Nomination for Waters
Important to Anadromous Fish

ANADROMOUS WATERS CATALOG/ATLAS
CORRECTION FORM

WATERWAY NUMBER: 111-50-10620, 2016 & 2020

DESCRIBE CHANGE(S): Revise hydro as shown on
attached photo. delete stream 111-50-
10620-2020. Shorten 111-50-
10620 & 10620-2016. as shown

jordan2.jpg

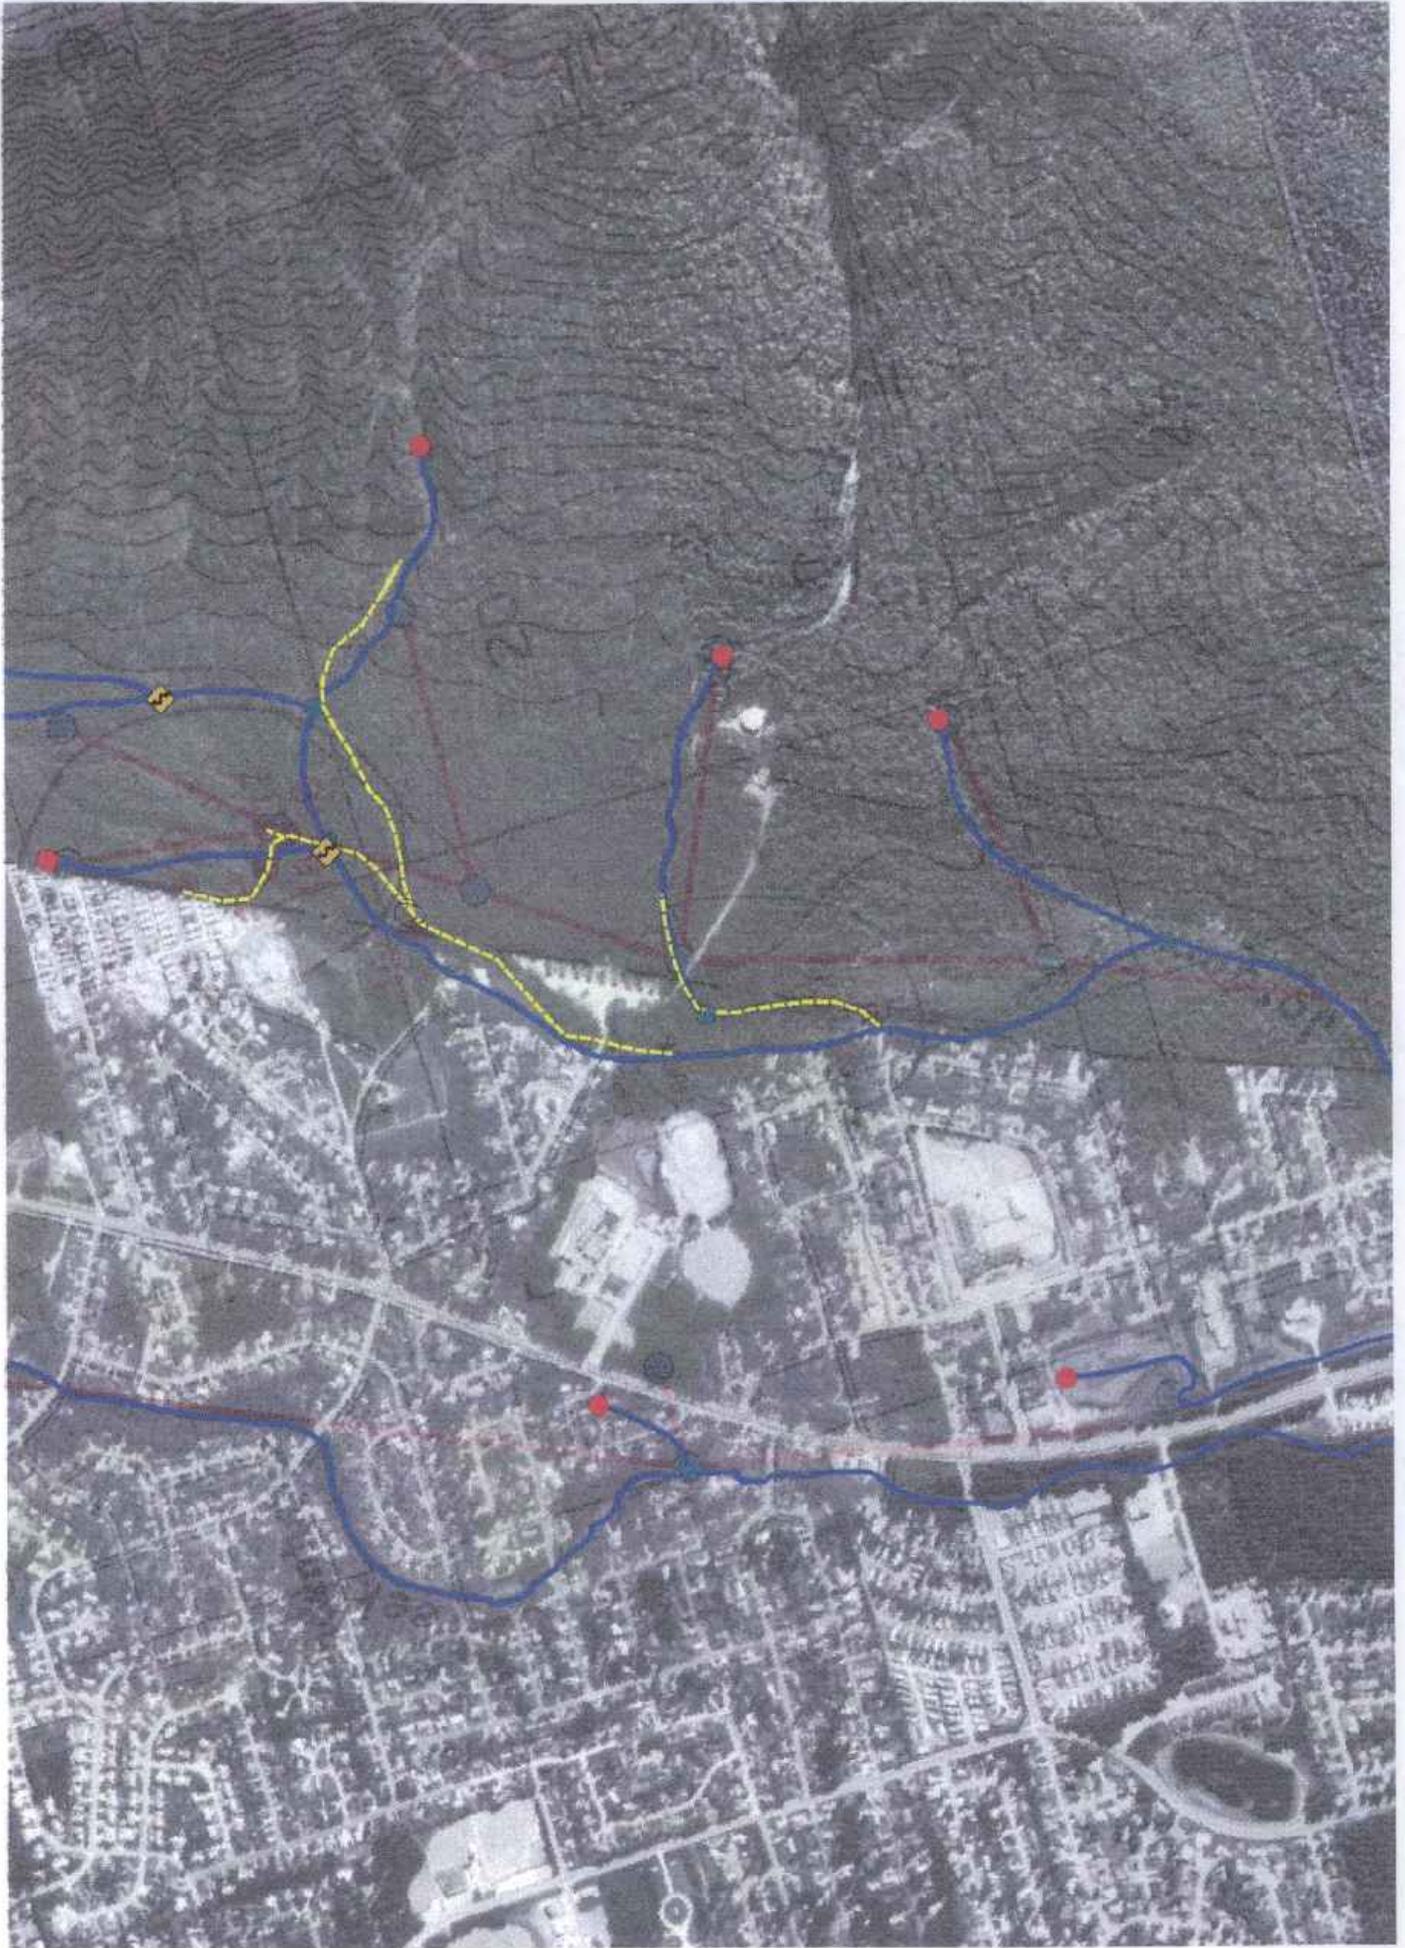
I'm getting ready to redraft the upper end and want to make sure I have things straight per the drawing and note you sent up earlier. The attached JPEG shows current draft AWC configuration (dark blue lines, red dots and green triangles), the yellow dotted lines are the changes I made per your GPS points, map and note. The map you sent up with the GPS points and the old stick AWC is muted in the background. And all this is overlain on the USFS ortho. Your note said that the streams to the east of the trailer park are "fantasy" which I interpret to mean they're not there. However, on the photo there does appear to be stream channels or old channels. Anyway before I delete them I just want to confirm that we know they are not there.

Also your note said that the stream confluence at point 15 was not cataloged. From the photo it appeared that this was the lower end of 2016 as I've drawn in yellow. Is this correct or is it actually a non cataloged stream? If 15 is an uncataloged stream, where does 2016 join up with the mainstem and can you send up a nomination for this new stream? Your note said we had observation info on it.

Also let me know if we need to adjust the upper extent on 2016, 2014 or 2010 since they look like they may be getting steep. This is probably more evident on 2016.

I would also like to assign the small nub at your point 17 as the upper extent of Jordan Creek and then reassign the ditch a second order number. Let me know if this will work for you guys. The small 150 foot part above the confluence with the ditch is unmappable otherwise. Also it may be cleaner to have the ditch as a separate stream than as a part of the Jordan mainstem. I also need to know how far up along the ditch to mark the upper reach. Your point 20 was the upper most GPS point taken but currently it's cataloged above this. Was it your intent for point 20 to be the upper point or do we have fish above this?

Rd, All I can say about 2016 is that it may have been or is an intermittent stream that does not occur anymore, or at a minimum, does not show up under this Spring's flow conditions. There are some channel structures in the vicinity of where 2016 should be, but currently they appear to have not seen water in some time as they contain fallen leaf litter and limbs. I will continue to examine that area under better flow conditions; and as I mentioned earlier, the Habitat people here will be surveying the entire drainage this year. As an added note, the dry channels that I just described to you are very short lived (less than 100 feet in length) and end abruptly as if they were incised by water spilling over from possible wetland areas, closer to the base of Thunder Mountain, into less stable soils near the mainstem of Jordan Creek. It is likely the water table in that wetland type area nearer Thunder Mnt. is now deeper in the ground and thus does not flow to Jordan Creek as a surface flow. Let me know if we can hold off on removing 2016 until we have the opportunity to examine the area under more normal flow conditions. Thanks for your efforts, Brian

Just want to confirm a few things regarding Jordan Creek. Given the map you sent and our previous discussions. The changes will result in the deletion of Jordan Creek tributaries 2020 and 2016, and the shortening of the mainstem Jordan Creek to just above the confluence with Rieds Ditch. I will be reassigning the portion of Rieds Ditch below the trailer park with a
